PROJECT NAME:	TOPSHAM FILTRATION FACILITY		
	CONTRACTOR:	MWH CONSTRUCTORS	
	ARCHITECT:	CDM SMITH	
OWNER:	BRUNSWICK & TOPSHAM WATER DISTRICT		
	REV. #	1	REASON: REVISED PER ARCHITECT REVIEW
	2	REVISED PER ARCHITECT REVIEW	
3	REVISED PER ARCHITECT REVIEW

GILFORD, NH - INFO@KHDRAFTING.COM	PROJECT NAME: TOPSHAM FILTRATION FACILITY	REV. #	REASON:
	CONTRACTOR: MWH CONSTRUCTORS	1	REVISED PER ARCHITECT REVIEW
	ARCHITECT: CDM SMITH	2	REVISED PER ARCHITECT REVIEW
OWNER: BRUNSWICK & TOPSHAM WATER DISTRICT	3	REVISED PER ARCHITECT REVIEW	
4.01

2 30 ACM BASE @ DOOR HEADER
ARCH. REF: 5/A-43

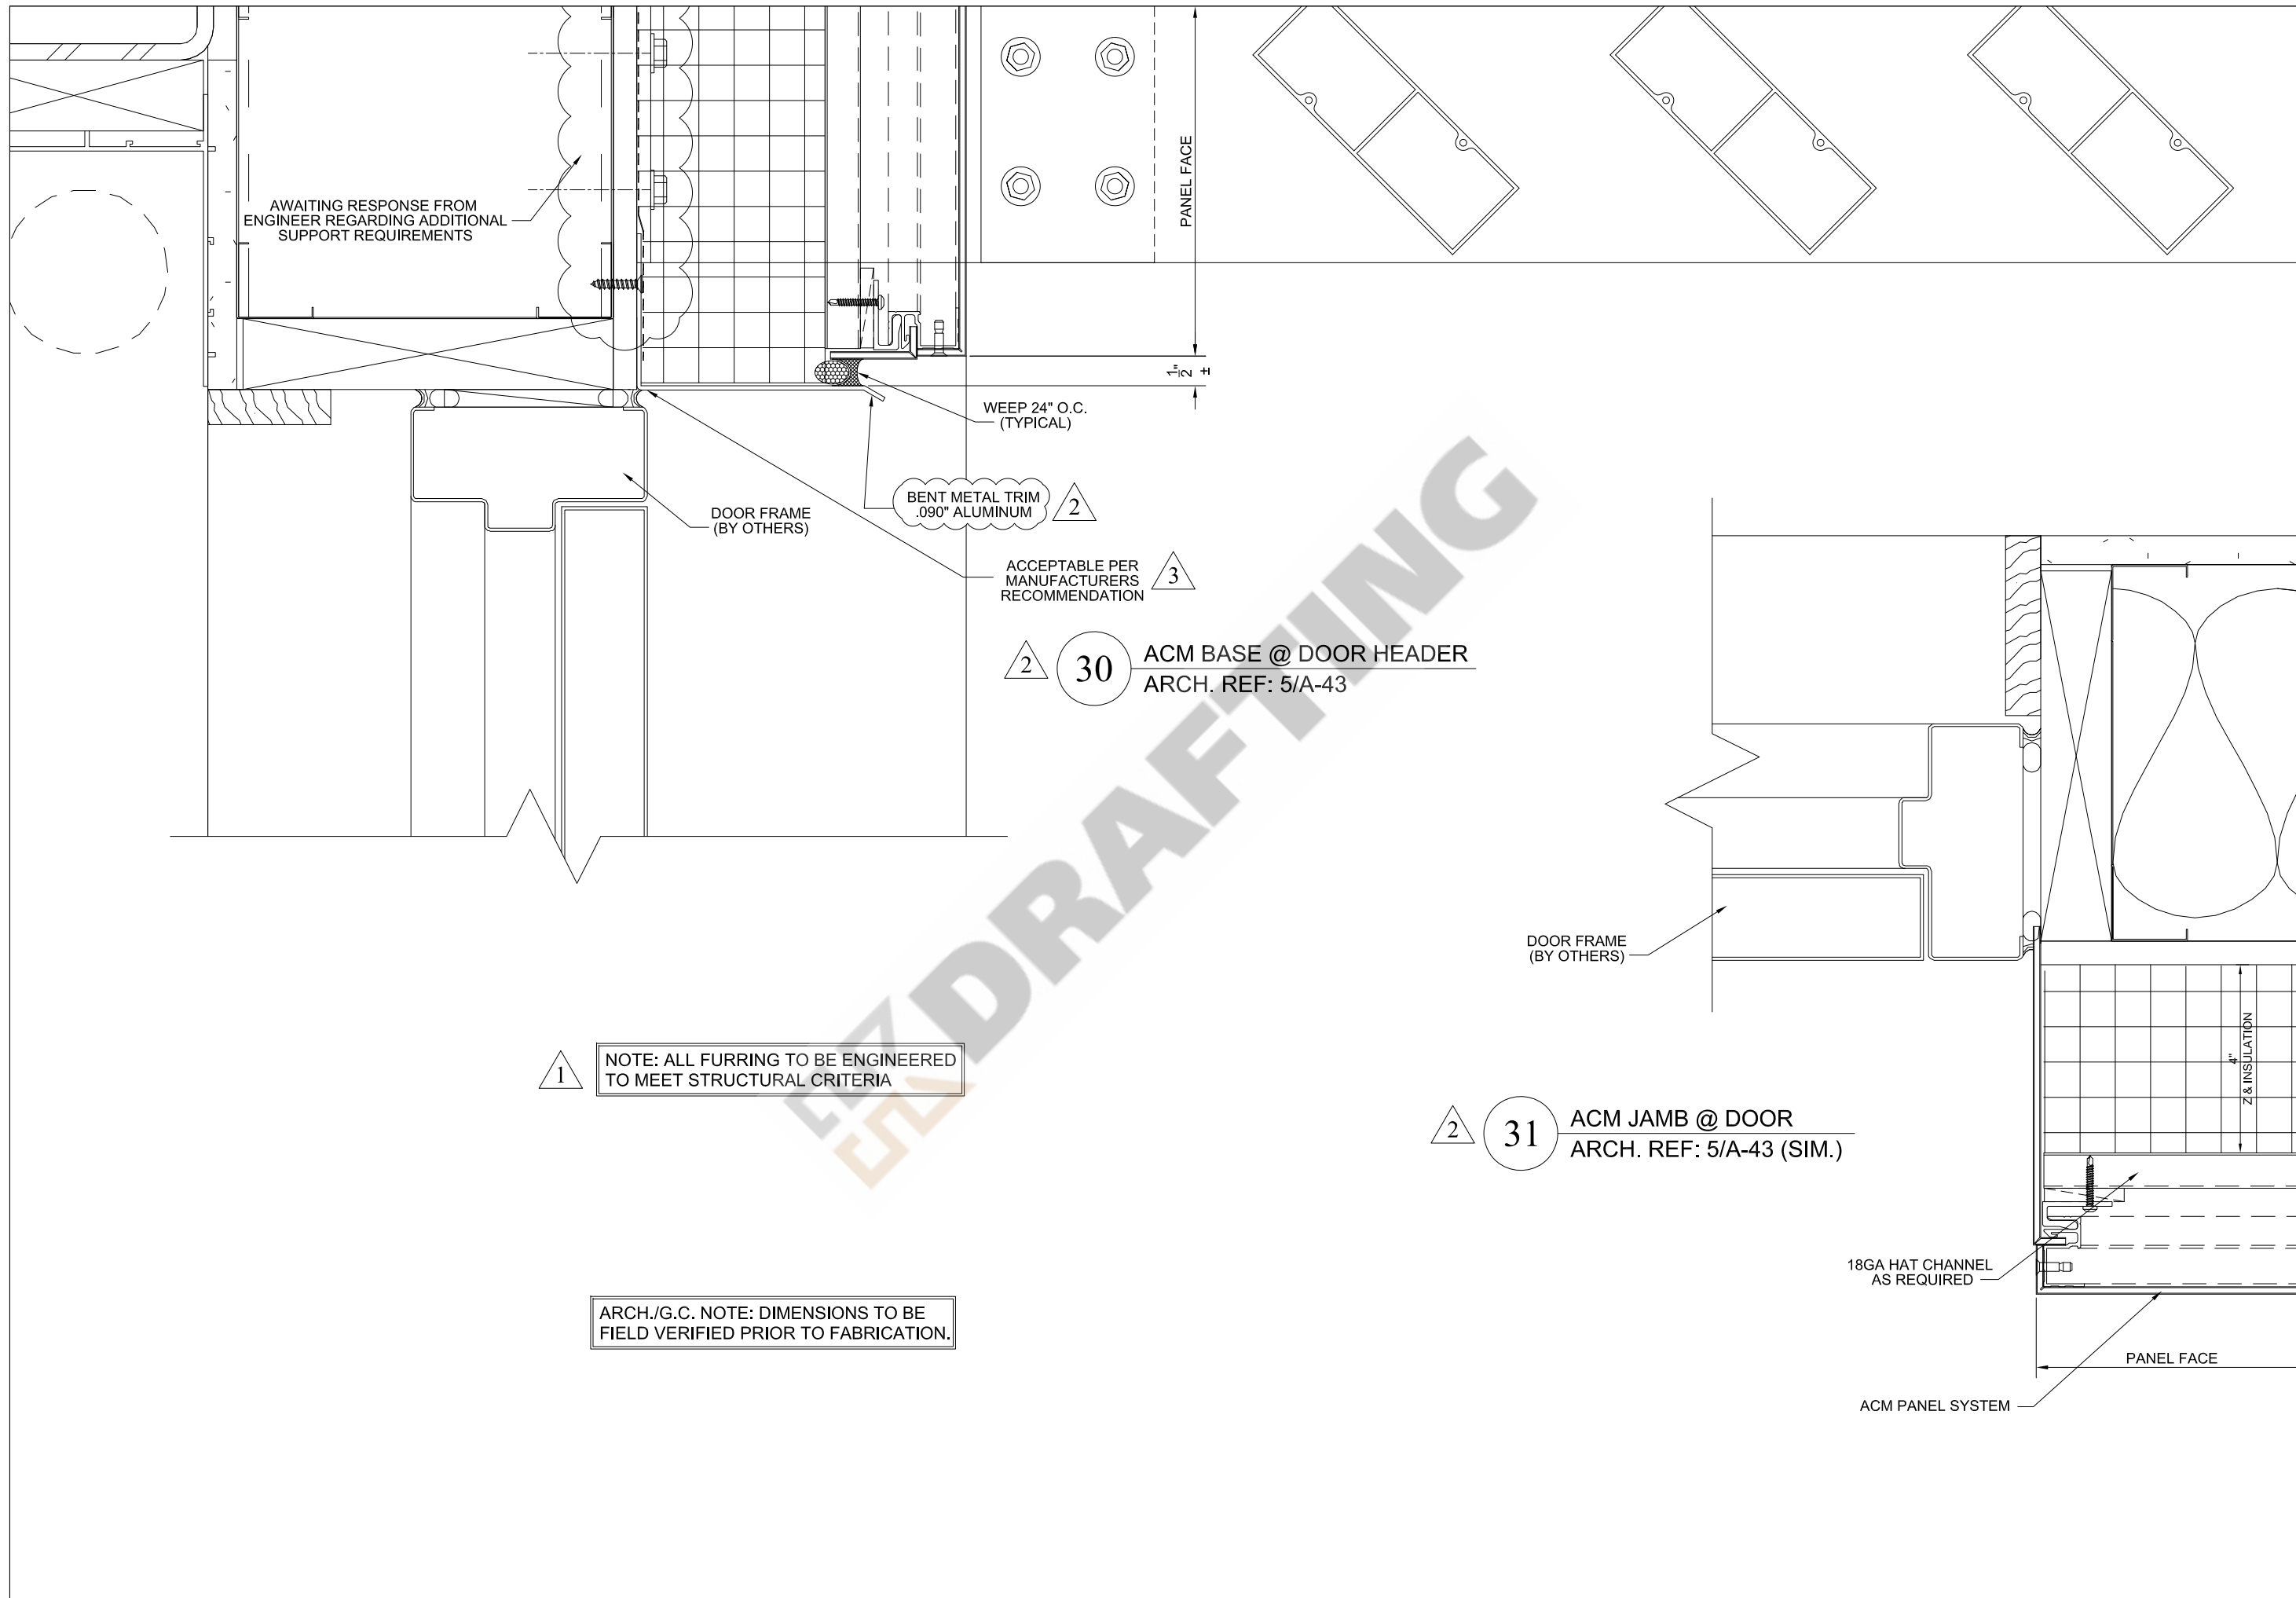
AWAITING RESPONSE FROM ENGINEER REGARDING ADDITIONAL SUPPORT REQUIREMENTS

ACCEPTABLE PER MANUFACTURERS RECOMMENDATION
